Specific Plan 5 Addendum
Final EIR 81-3
City of Fontana
October 1981

**Southridge
Village**

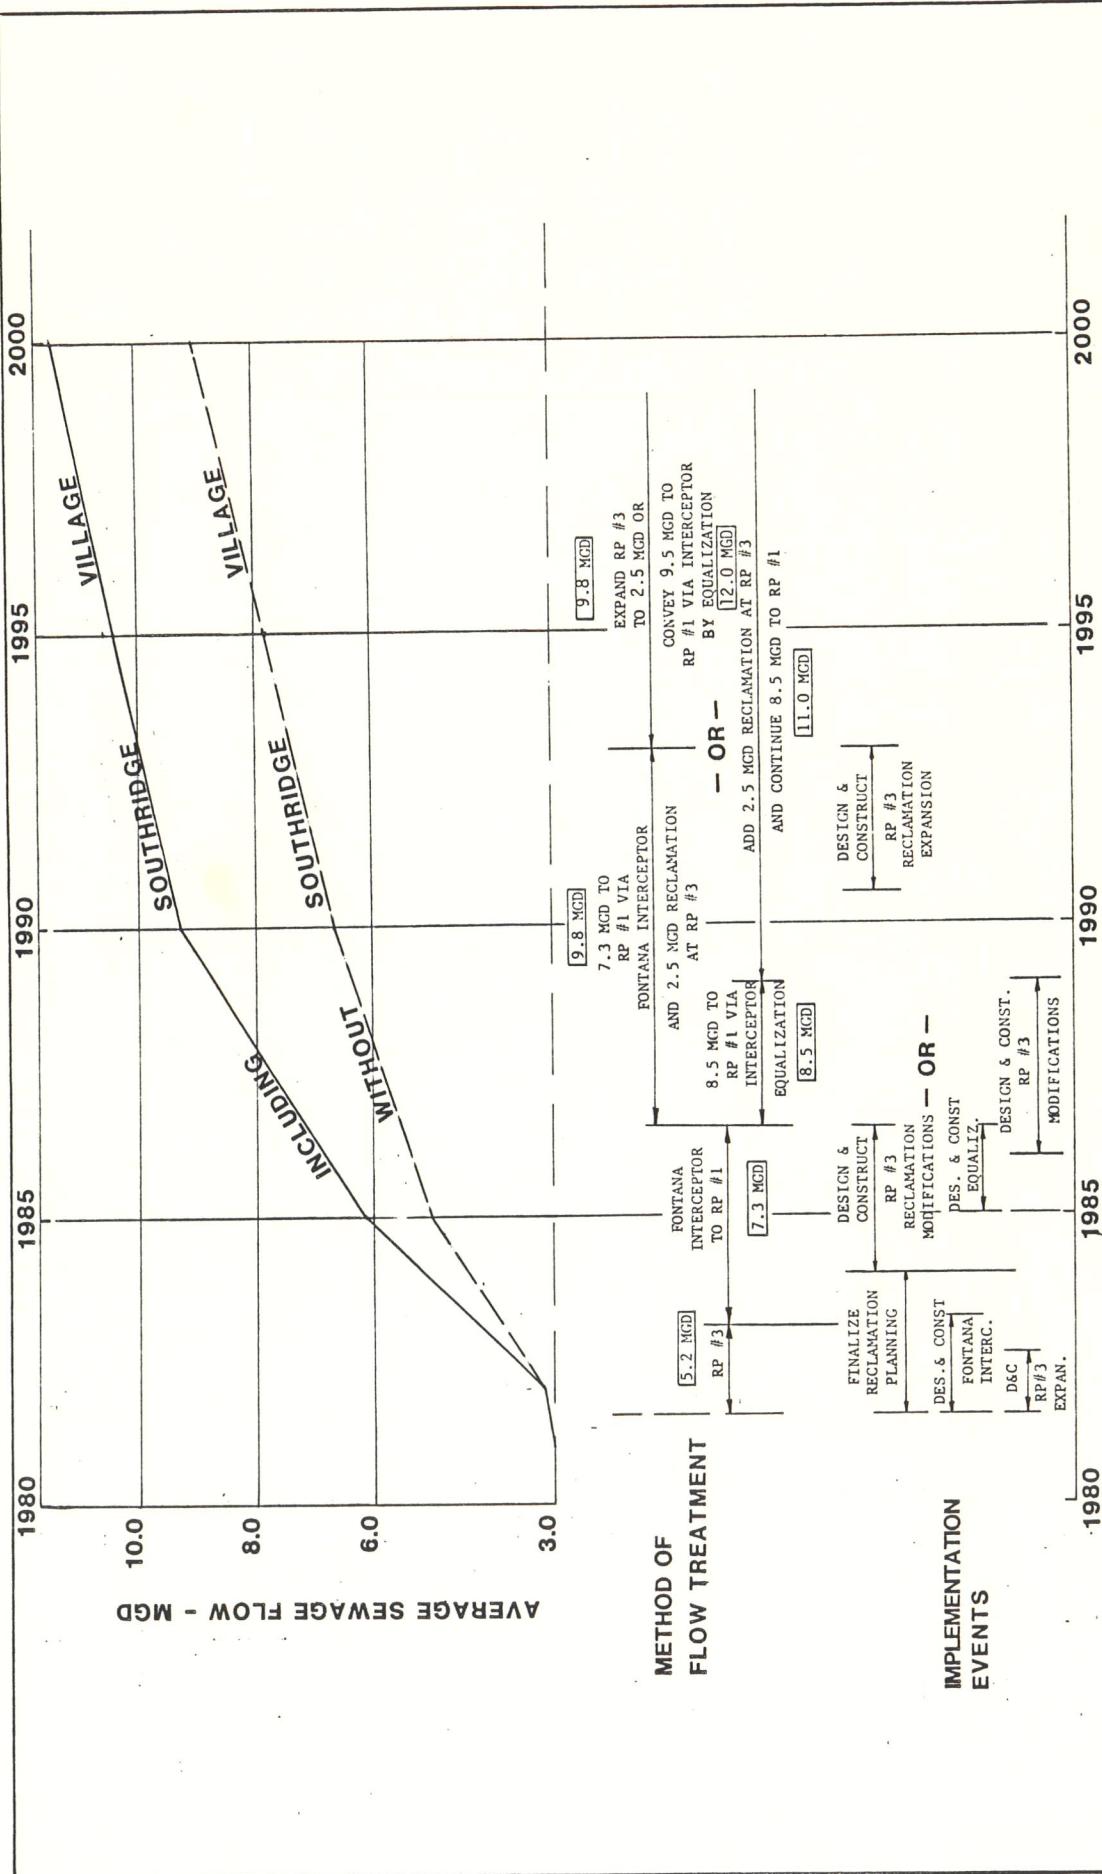
Figure 1, excerpted from the Boyle Engineering report, illustrates the projected average sewage flow, the methods of flow treatment, and a schedule of implementation events. A summary of the major features of the recommended sewerage system program is provided below.

Phase One. The existing Regional Plant No. 3 would continue in operation, with improvements added to treat and dispose of 4.0 or 4.25 mgd. This capacity should be reached in 1983.

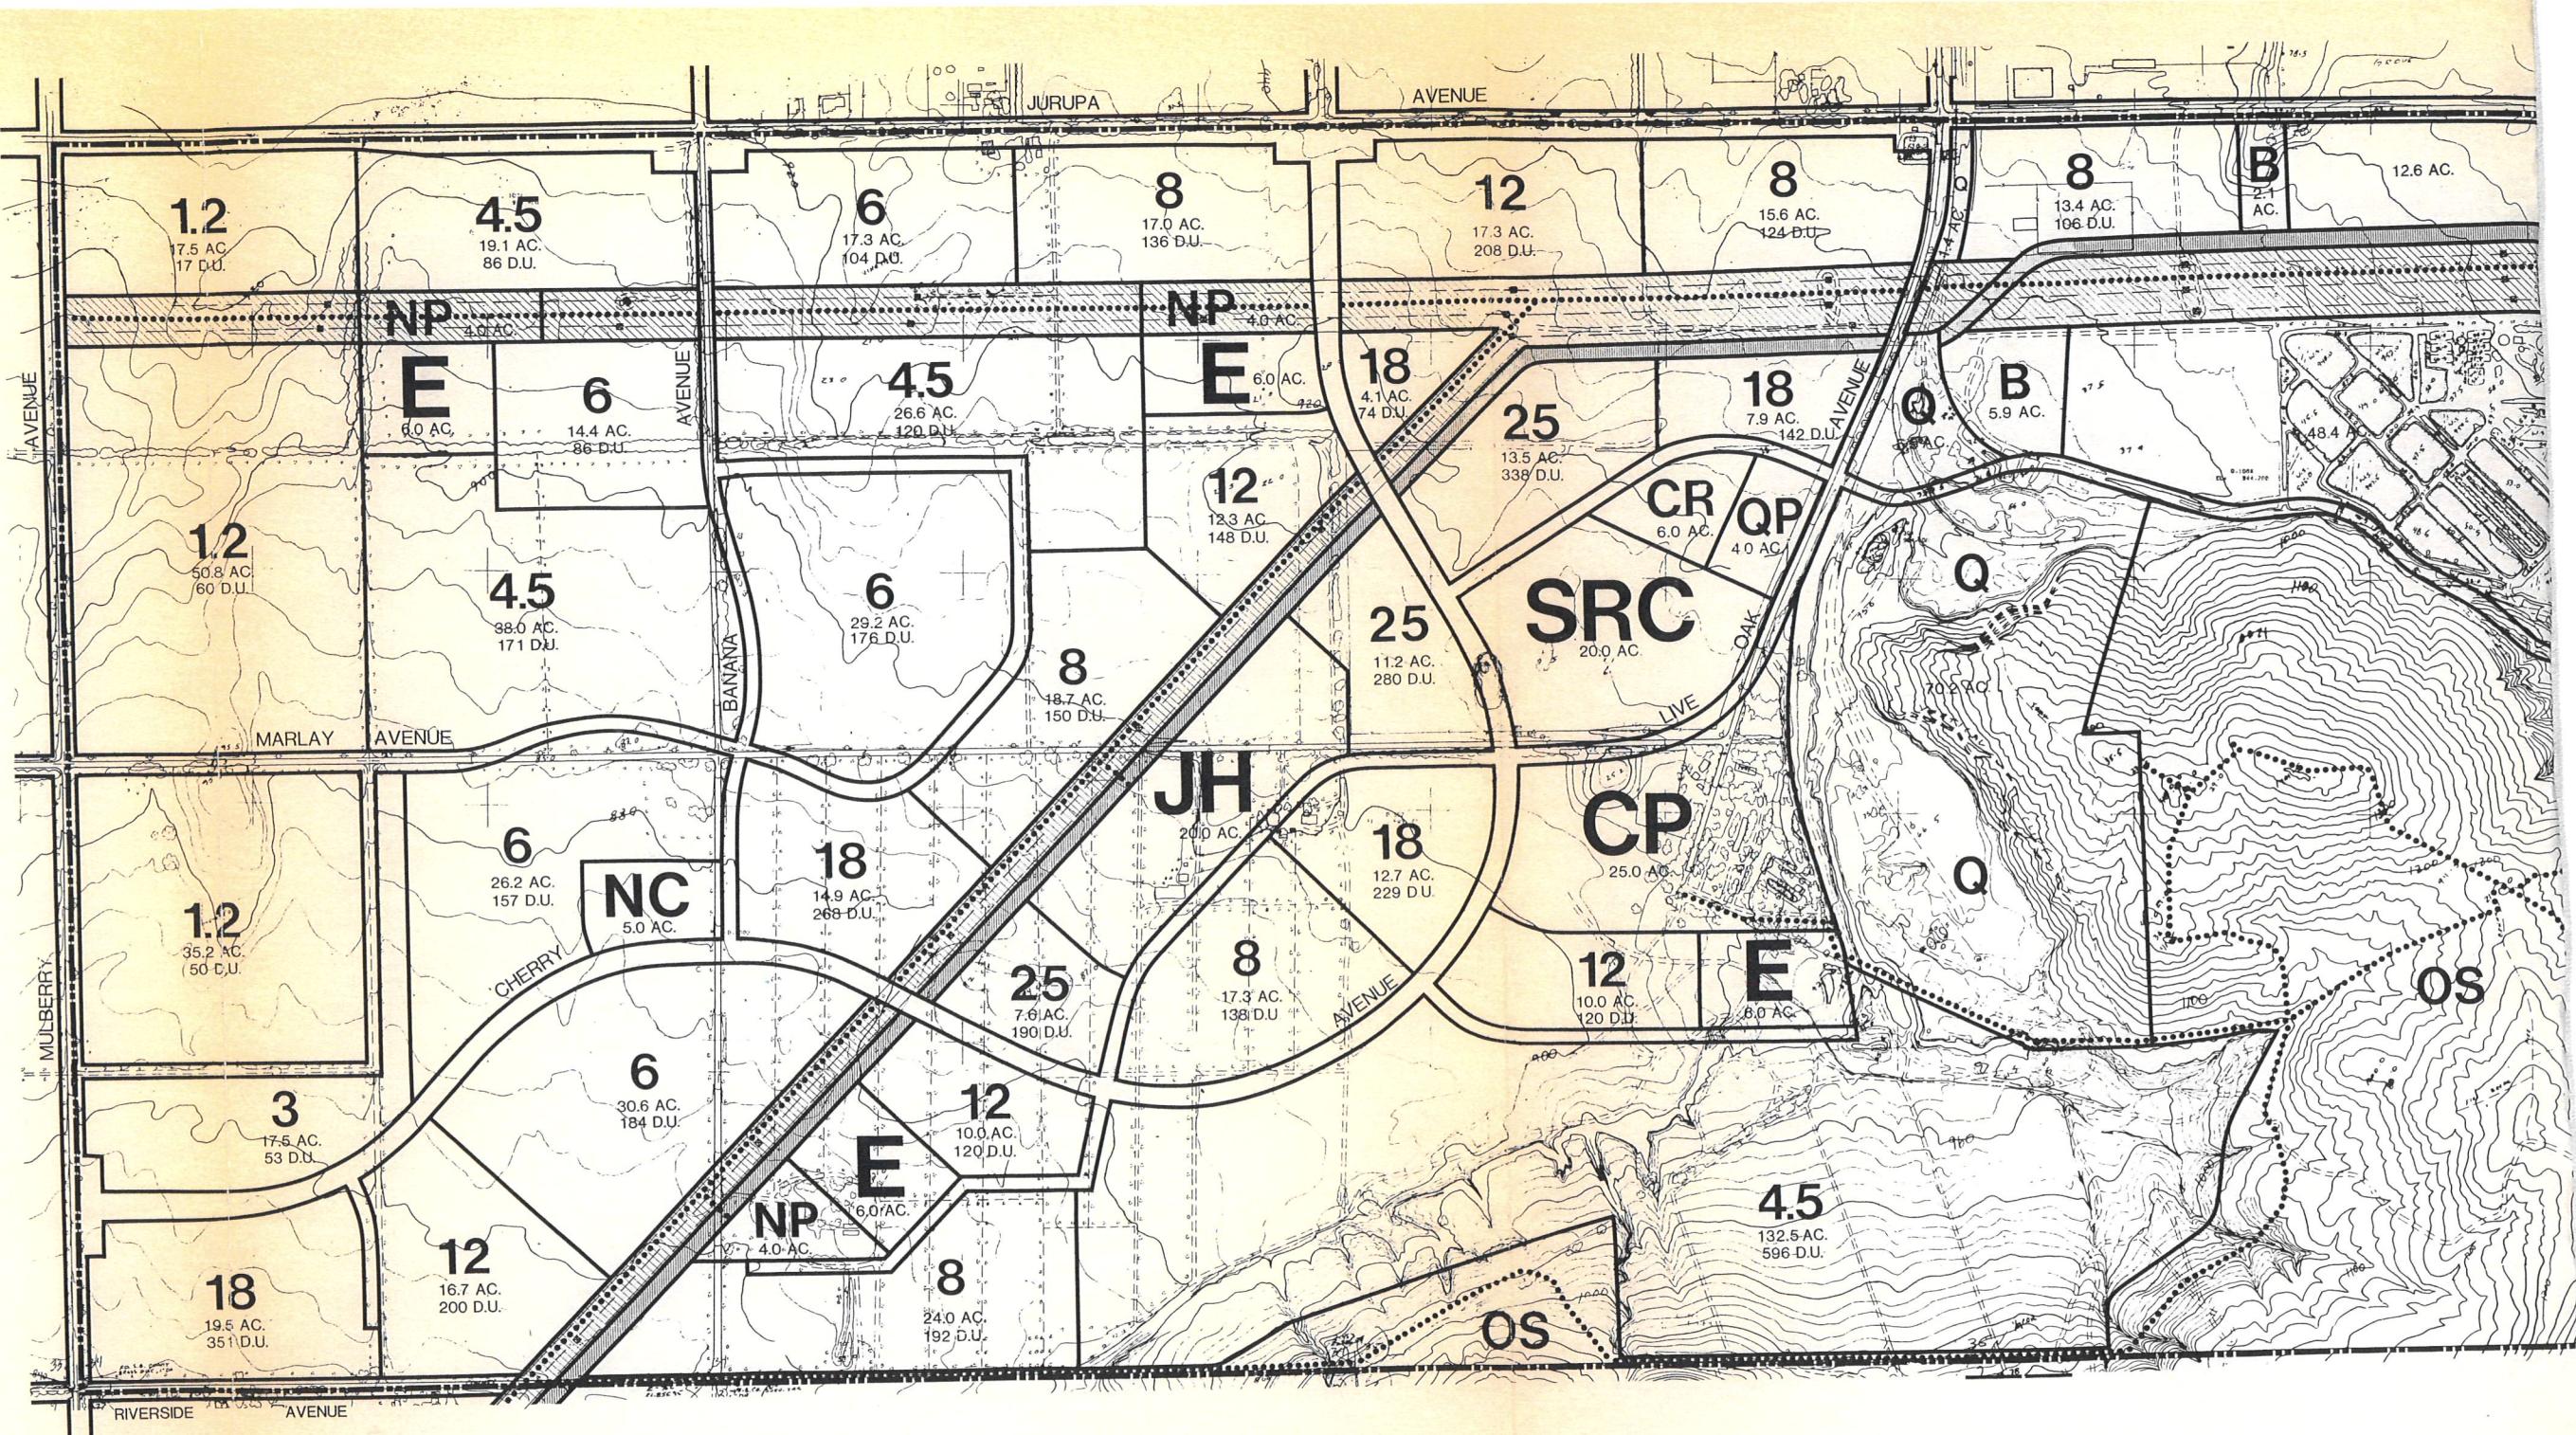
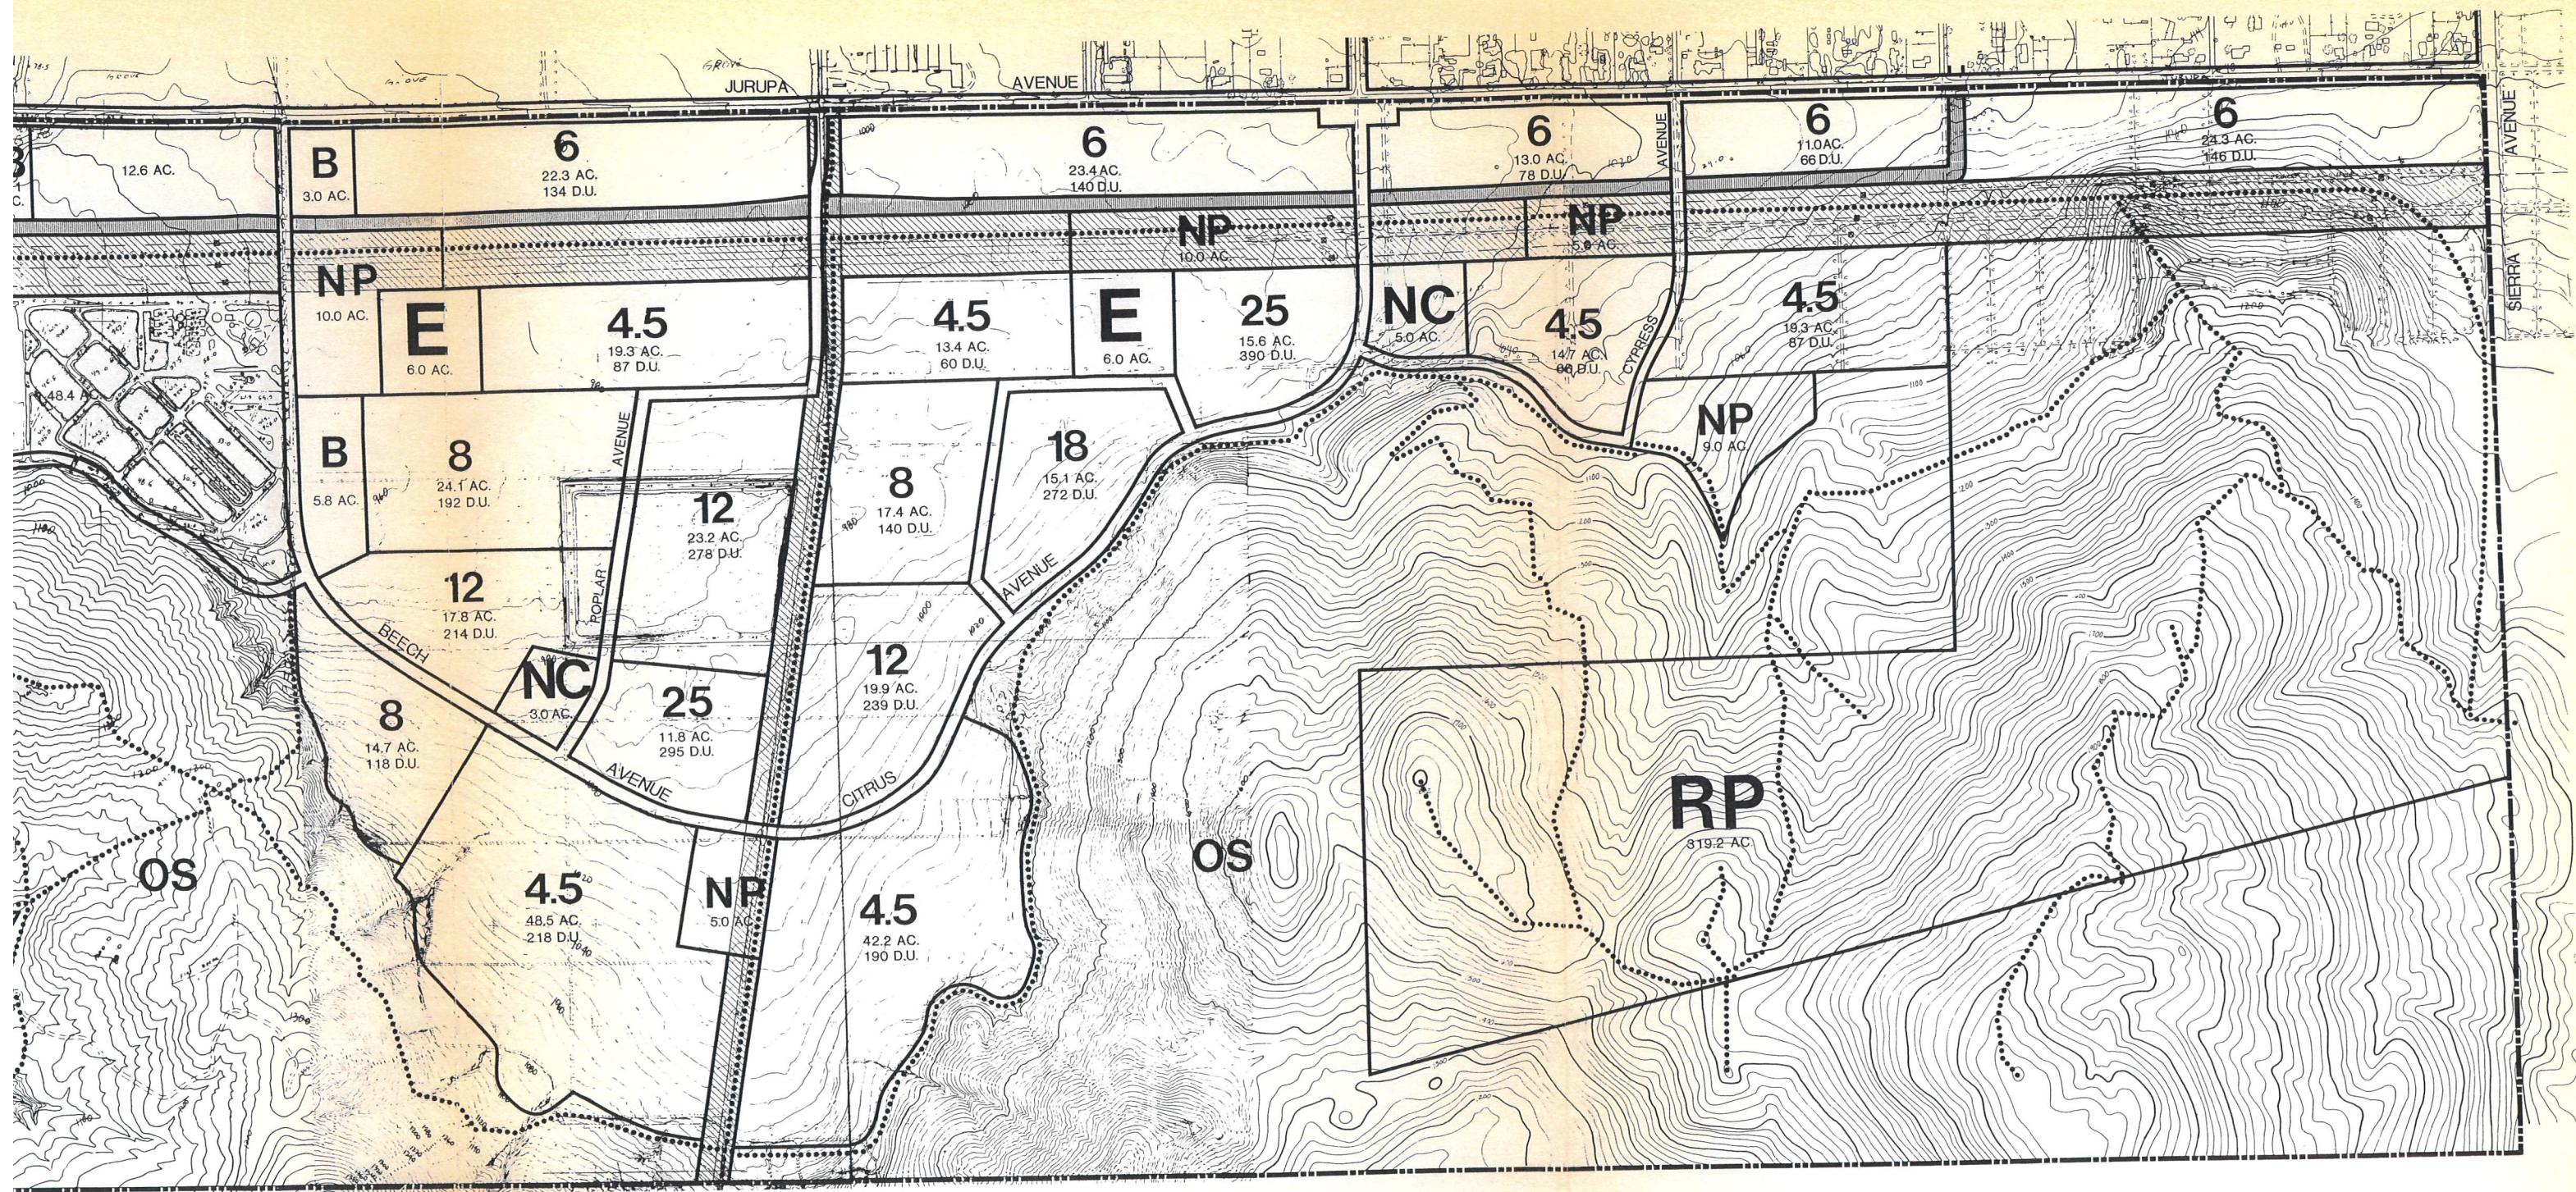
Exhibit 3.1, the Land Use Master Plan presented in the Draft Specific Plan document, has been revised. The revised Land Use Master Plan recommended for approval is included in this Specific Plan Addendum, and is designated "Specific Plan B-4." Major changes in the Land Use Master Plan include the following:

3. Neighborhood and community park acreage has been expanded substantially, consistent with the recommendations of the Parks and Recreation Department. Additional neighborhood parks are proposed east of Regional Plant No. 3 and in the vicinity of the "Fontana Pit and Groove" archaeological site. The community park south of the sub-regional center has been expanded.

4. A buffer zone is proposed adjacent to Regional Plant No. 3, consistent with the recommendations of Chino Basin Municipal Water District.
5. The Southern Pacific Railroad quarry property has been designated for "Quarry" use, consistent with the City Council's decision on the General Plan Amendment.

6. Some elementary school sites have been relocated, to better reflect the expected distribution of students and to provide greater land use compatibility.

7. Residential density assignments have been shifted, to meet the target density of 8800 units and to respond to other changes in the land use plan and concerns raised during the review of the draft Specific Plan.

8. An "Open Space" designation has been added, replacing the "Regional Park" designation on land not owned by the City. The "Open Space" designation would permit very low density residential use with a minimum lot size of 20 acres.

The alignment of the Declez Channel has been changed to accommodate the construction of flood facilities southerly of the County line. The new channel alignment is shown on the revised Land Use Master Plan. The channel now goes from the County line on the southeasterly side of the diagonal Edison easement, continuing on the south side of the east-west Edison easement to Live Oak Avenue. At this point it will cross to the north side and will follow the north side of the easement to Cypress Avenue. From this point easterly, it is anticipated that the facilities will be an undergorund storm drain within the Jurupa Avenue right-of-way.

In response to concerns raised by Chino Basin Municipal Water District, the Land Use Master Plan has been revised to show a "buffer zone" east and west of Regional Plant No. 3. This buffer zone, together with a new neighborhood park site, will provide for a setback area between residential uses and the treatment plant. Permitted uses within the "Buffer" land use designation are described in Chapter 4.0 Development Standards of this Specific Plan Addendum.
